REMARKS/ARGUMENTS

Appl. No. 09/989,897
Amdt. dated January 21, 2005
Reply to Office action of October 22, 2004

FIG. 8

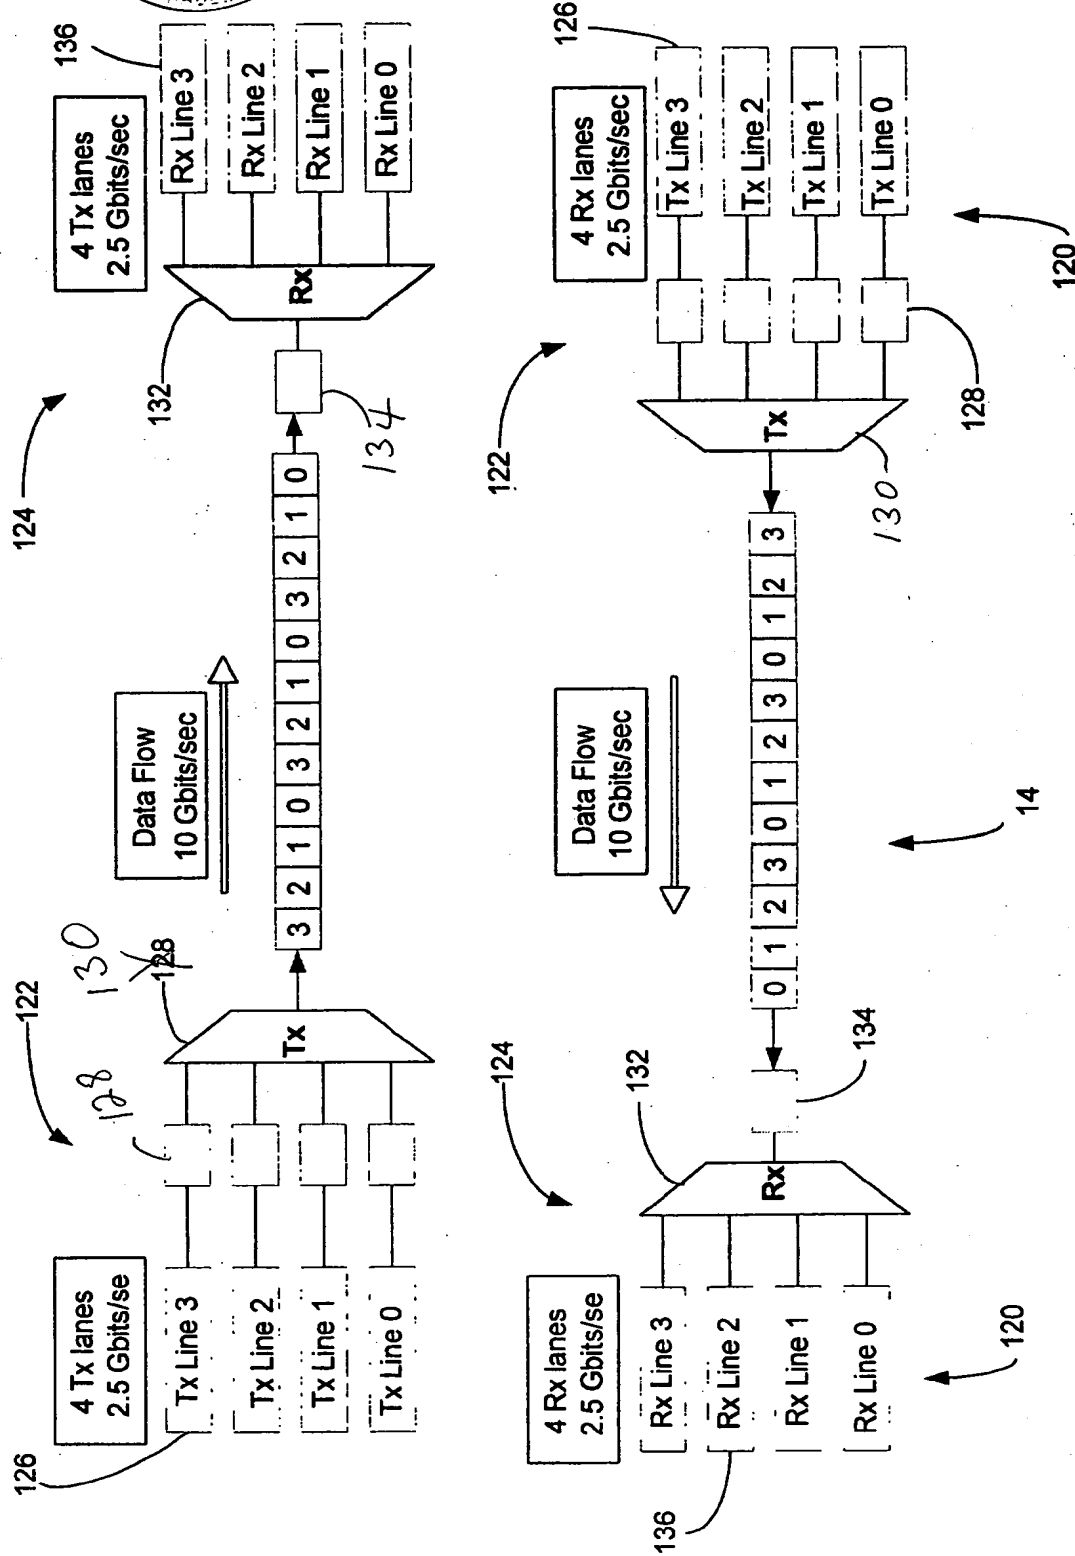
The Examiner objected to Figure 8 because the reference numeral designations for some of the blocks are inconsistent with the specification. Specifically, data recovery modules 128, 134 and multiplexer 130 are not consistent with the specification. The Applicant thanks the Examiner for bringing these clerical mistakes to his attention and hereby amends Figure 8 as illustrated in the Appendix.

The attached sheet of drawings includes changes to Fig. 8. This sheet replaces the original sheet including Figs. 8. In Figure 8, previously omitted elements 130 and 134 have been added. Element 128 has been corrected to be consistent with the specification.
